**PILGRIM WATCH COMMENT REGARDING ADDITIONAL REQUIREMENTS FOR
CONTAINMENT VENTING SYSTEMS FOR BWRs WITH MARK I AND MARK II
CONTAINMENTS IN SUPPORT OF FILTERS (OPTION 3) AND RUPTURE DISCS**

Mary Lampert
Pilgrim Watch, Director
148 Washington Street
Duxbury, MA 02332
Tel. 781-934-0389
Email: mary.lampert@comcast.net
November 19, 2012

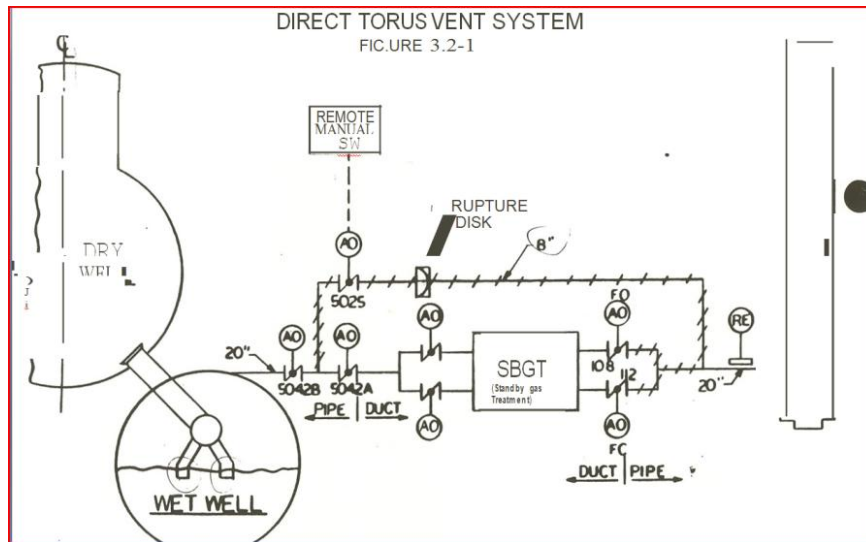
The following diagram, that shows the branch line with its own containment isolation valve 5025 and Rupture Disc, is included in the attachment to BECO's letter. It will be noted that the Rupture Disc is downstream of valves AO-5042B and AO-5025, and that both of these valves are normally closed and are designed to be opened either remotely from the control room or manually.²³

In other words and greatly simplified, the DTV will vent excess pressure from the containment *only* if normally closed valves AO-5025 and AO-5042b can be opened.

Pilgrim's control room has 2 key locked switches in series that have to be opened manually when the need to use the DTV occurs. If, as happened at Fukushima, the normally-closed isolation valves cannot be opened from the control room, the next step is to try to open the isolation valves manually – but this also proved impossible at Fukushima since radiation levels were too high.

Failed Valves: Pilgrim's DTV isolation valves appear to be essentially the same as those that failed at Fukushima. Supposedly "automatic" systems do fail (as they did at Fukushima) and manual systems may also (both mechanically and because radiation is too high to permit manual operation). Why is there no redundancy?

²⁴ Redundancy, of course, could have been provided at both Fukushima and Pilgrim, e.g., by a parallel vent line with a 50-55 psig rupture disc followed by a normally open valve that would be closed when pressures had dropped to an acceptable level, but that would have cost the industry more money.
